S-Type	Date 07/99	S204-03
TECHNICAL BULLETIN		
Subject REPLACEMENT SUSPENSION SPRINGS		Model S-Type Year 1999.25 Onwards VIN L00600 Onwards

Suspension spring and packing ring (arrowed)

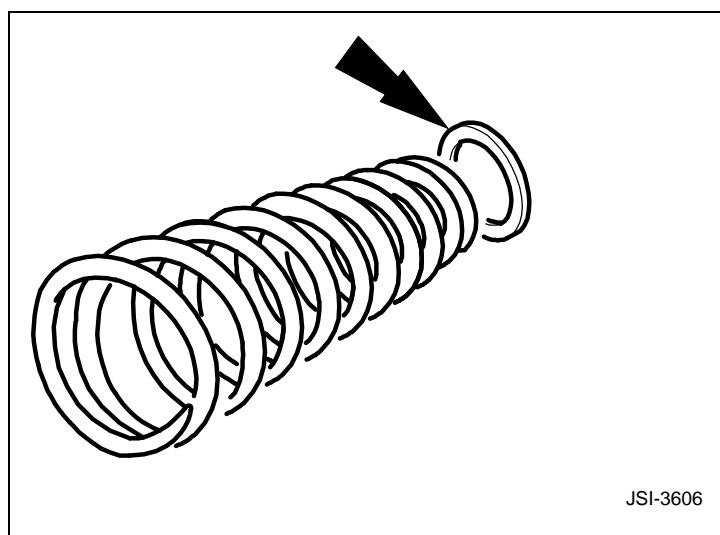
When 'short-tolerance' springs are built up into suspension assemblies, a 3mm packing ring is inserted under the spring, to maintain the correct ride height of the vehicle. No packing ring is fitted where 'long-tolerance' springs are assembled. Any one vehicle may have any combination of 'long-tolerance' and 'short-tolerance' springs fitted as original equipment.

**All** replacement springs supplied via Jaguar Parts Operations are selected as 'long' tolerance springs, and **must not** have packing rings fitted below them.

Where it is necessary to fit a replacement spring to an S-Type vehicle, examine the existing condition.

In any location where a 3mm packing ring is found under the existing spring, discard the packing ring before fitting the replacement spring.
